STAFF REPORT: JULY 10, 2024, REGULAR MEETING
APPLICATION NUMBER: HDC2024-00331
ADDRESS: 1730 EDISON
HISTORIC DISTRICT: BOSTON-EDISON
APPLICANT/OWNER: ANDRE GILBERT
DATE OF PROVISIONALLY COMPLETE APPLICATION: JUNE 12, 2024
DATE OF STAFF SITE VISIT: JUNE 24, 2024

SCOPE: REPLACE WOOD WINDOWS WITH ALUMINUM-CLAD WOOD WINDOWS

Selected images showing deterioration. Please see application documents for full, higher-resolution images.

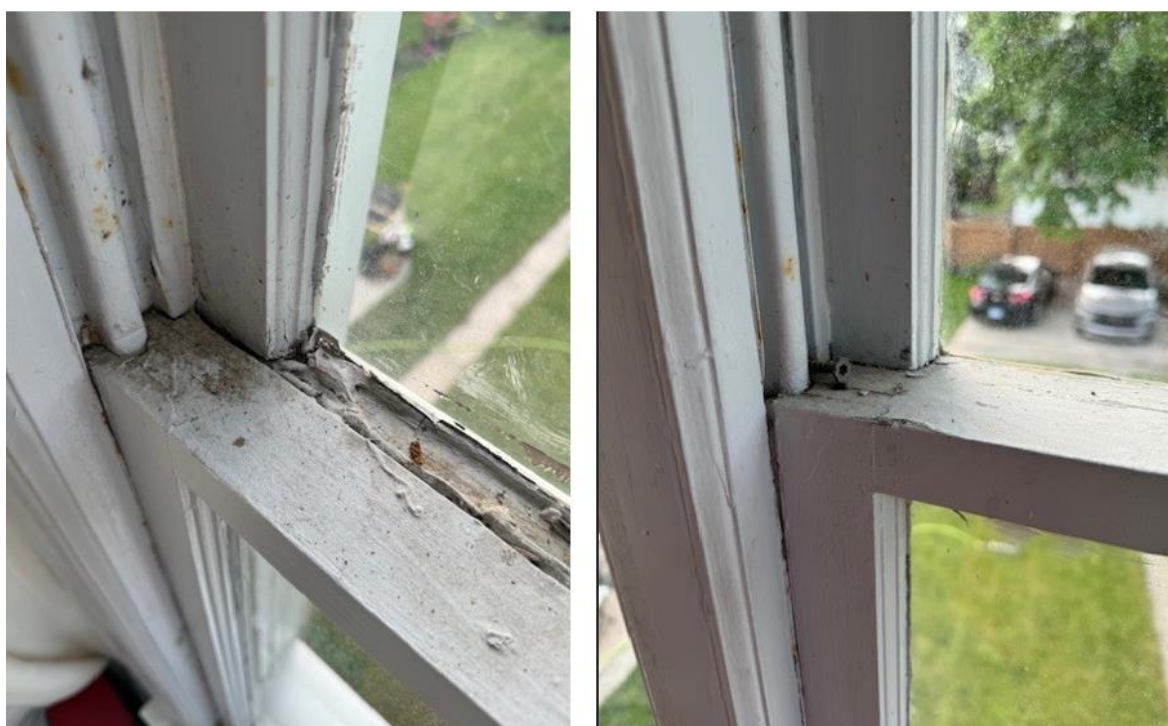
- The applicant has provided detailed interior and exterior photographs along with a written description of each window. For example, five of the windows are described as having areas that are “soft to the touch” and all ten described as “not flush with the sill.”

- From the photos provided by the applicant, staff observes that there are several patches and repairs to the windows and that much of the hardware appears to be non-original.

- Based on photos provided by the applicant, staff concurs that the second-floor windows (numbered 6 through 10 in the application documents) are likely not original or historic, for the same reasons provided by the applicant above. The replacement of non-historic windows is appropriate if the new windows are compatible with the property and the district.

- The first-floor windows (1 through 5) appear to be original or historic, though they have seen extensive repairs. In viewing the photos and written descriptions provided by the applicant, staff observes a noticeable degree of deterioration. Staff suggests that this information, along with the professional opinions noted above, indicates that replacing all ten windows with good matches may be reasonable and appropriate under the Standards.¹ The Secretary of the Interior’s Standards, namely Standard #6, allow character-defining features to be replaced when beyond repair: “Deteriorated historic features

Staff recommends that the Commission issue a Certificate of Appropriateness for the proposed work as it meets the Secretary of the Interior's Standards for Rehabilitation, with the following condition:

- Historic window casing and brickmould, if any remains, must be preserved.
